ADDENDUM 01

Keyo Electrical Service Upgrade University of Maine

Re Addendum No. 1 to the Construction Documents for:

University of Maine
Keyo Building Electrical Service Upgrade
Orono, Maine
Project No. 24265

1 E50-1 - POWER RISER-SE
NO SCALE

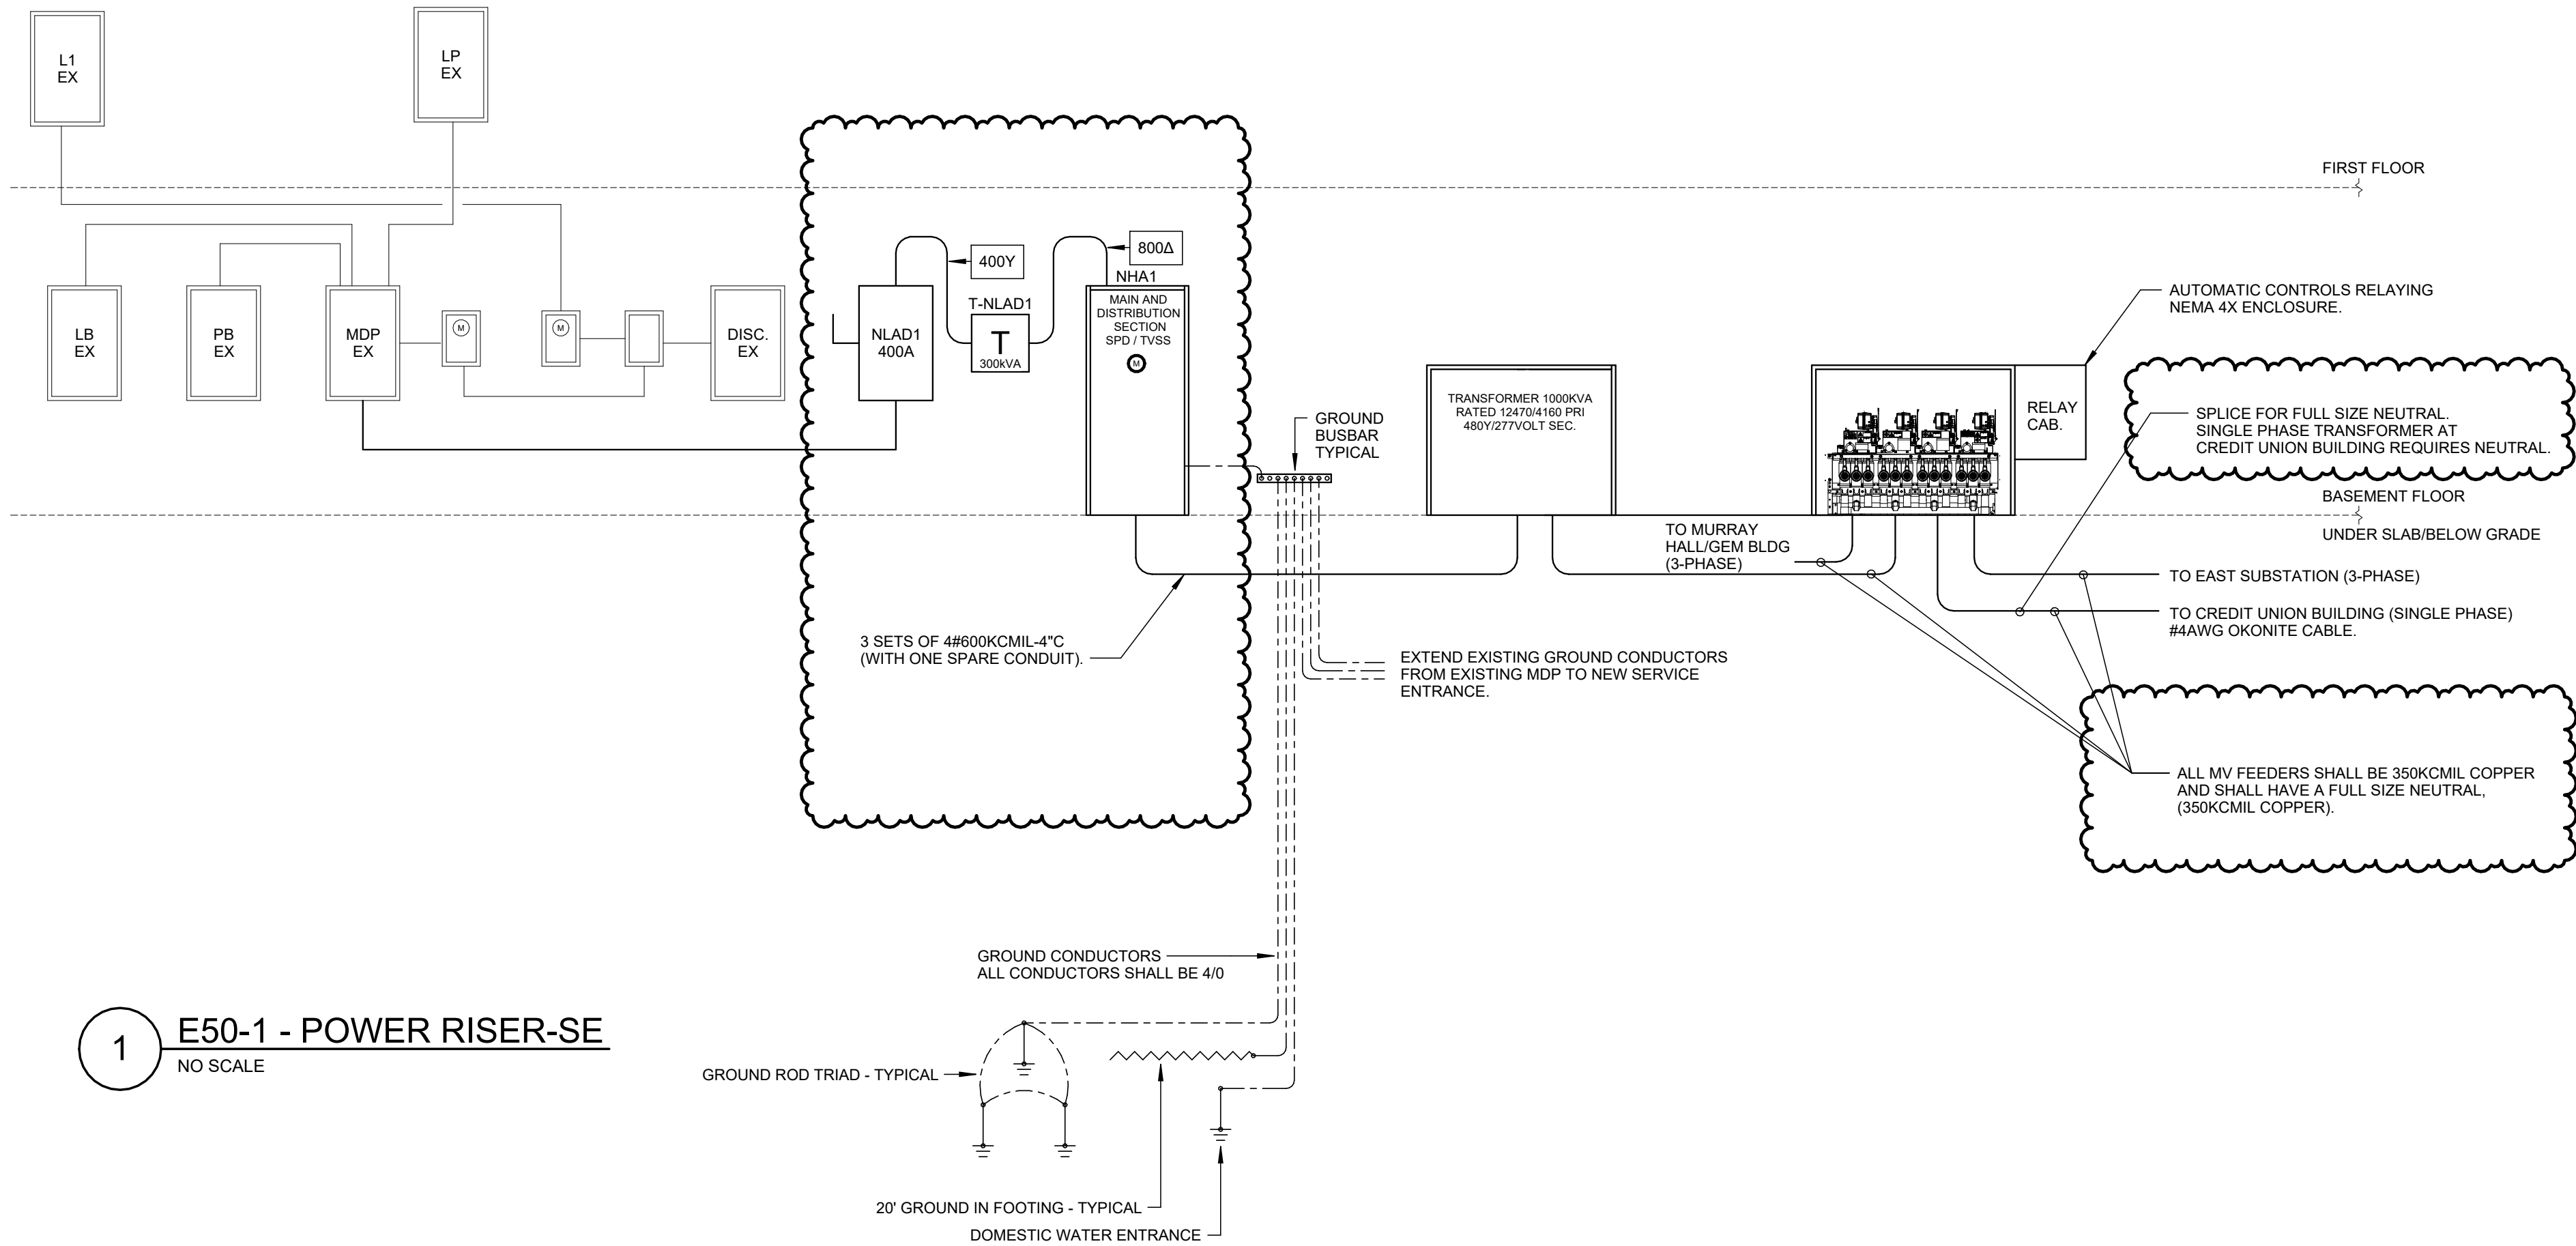
- Q1. What size are the primary conductors feeding the new owner supplied switchgear and transformer?
- A1. 350kcmil Copper with Full Size Neutral has been noted on drawing E50-1 as a part of this Addendum.**

- Q3. E20-0 shows NLAD1 being 400A, whereas the one-line diagram on E50-1 omits the amperage value and shows it being fed with "1200Y" from T-NLAD1. Please confirm what amperage NLAD1 is.

- A3. NLAD1 shall be rated 40A. The wire size feeding NLAD1 will be updated to 400Y on the riser diagram E50-1.**
- Q4. Deduct alternate on C40-1 and drawing E80-1 requests that conductors be pulled in the new 4" conduit from EHH-3 to the new switch pad. What conductors are to be pulled in this conduit? Additionally, this conduit is tagged as "NUC" for communications, but it appears to terminate at the switch pad. Please clarify the correct point of termination for this conduit. Also, please confirm whether this conduit can be PVC or if it will need to be RTRC.

- A8. Provide 4-4" conduits with 3 sets of 600kcmil-4"C with one spare conduit. Electrical drawings E50-1 and E20-0 have been updated to reflect this as a part of this Addendum.**

SITE PLAN

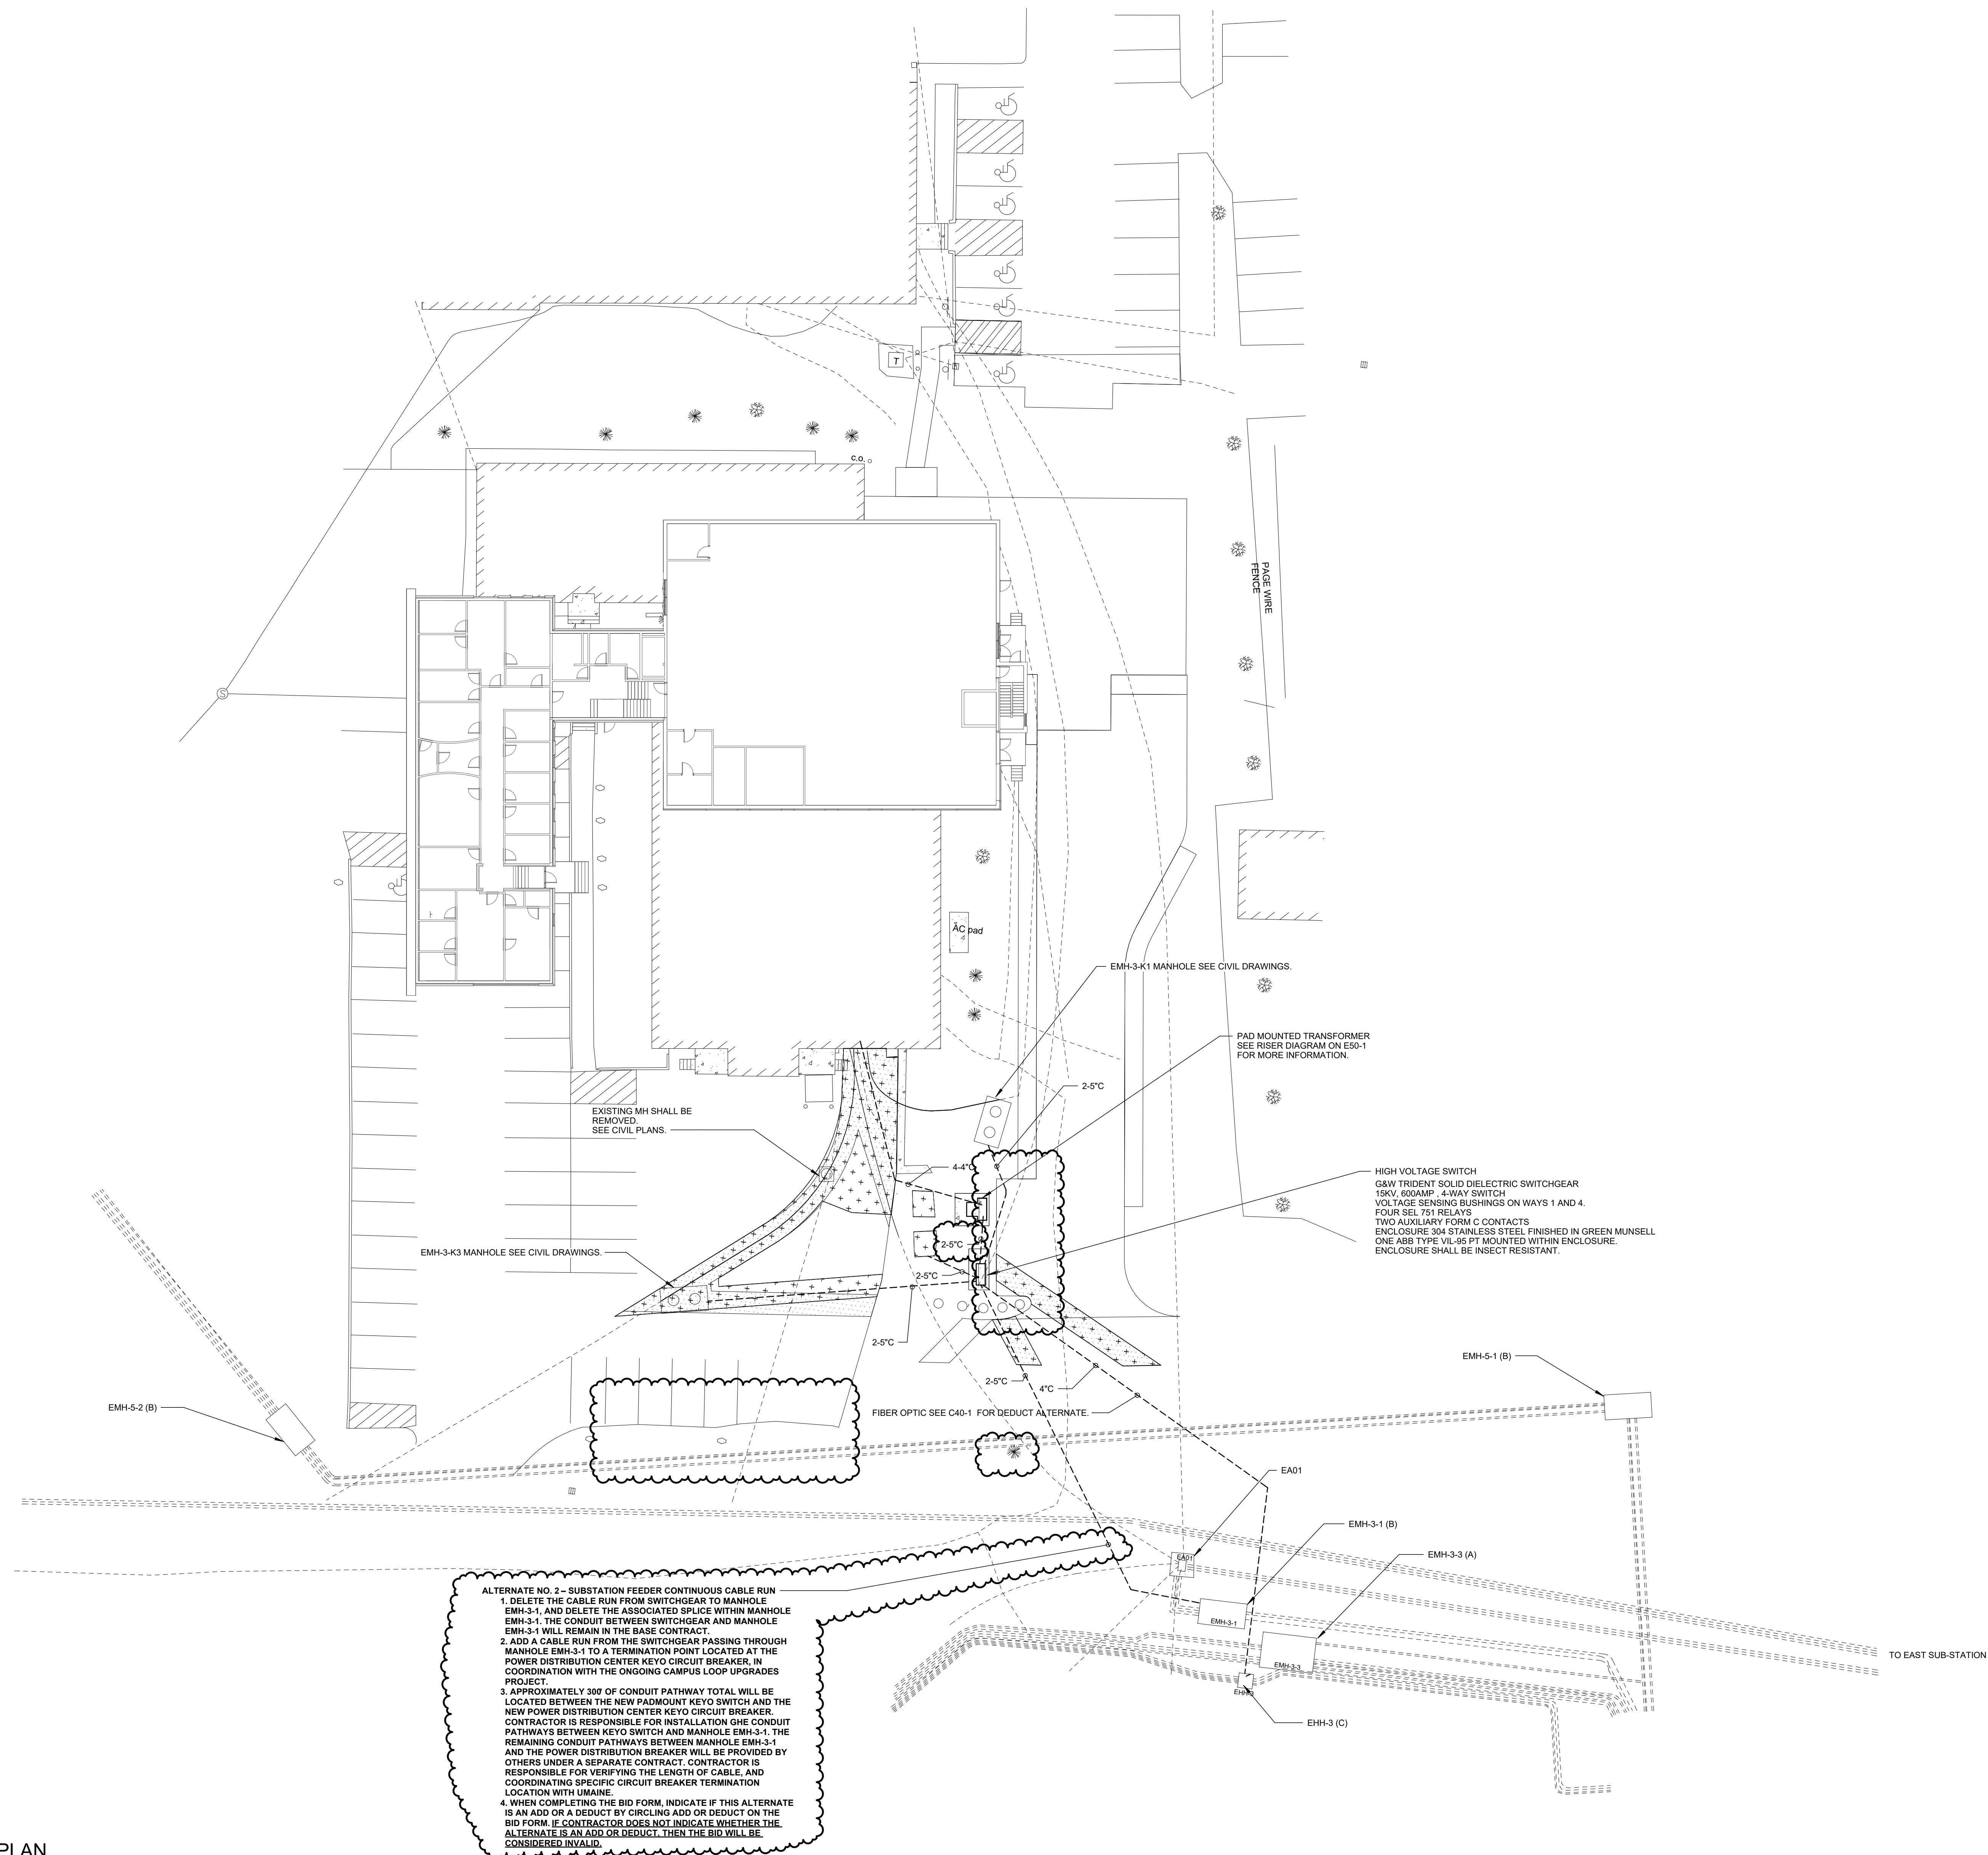
- Q5. Manholes EMH-3-K3 and EMH-3-K1 are shown on E80-1. Conversely, these manholes are not shown on C40-1. Are manholes EMH-3-K3 and EMH-3-K1 being used in this project? The new electrical manholes on drawings C40-1 and E80-1 appear to have conflicting locations. The electrical conduits also appear to conflict between the two drawings. Please confirm quantity and locations of manholes and conduits.

- Q6. Drawing E80-1 shows two 5" conduits exiting the switch pad and terminating in a grassy area in the direction of the Keyo building. Please confirm if these conduits are required.

- A5. Manhole labels to be added to C40-1 drawing to match E80-1 drawing. Locations of manholes and underground conduits on drawings has been adjusted to ensure exact location matching as a part of this Addendum.**

- A6. Yes, the conduits are required and shall terminate in manhole EMH-3-K1. See updated plan issued with this Addendum.**
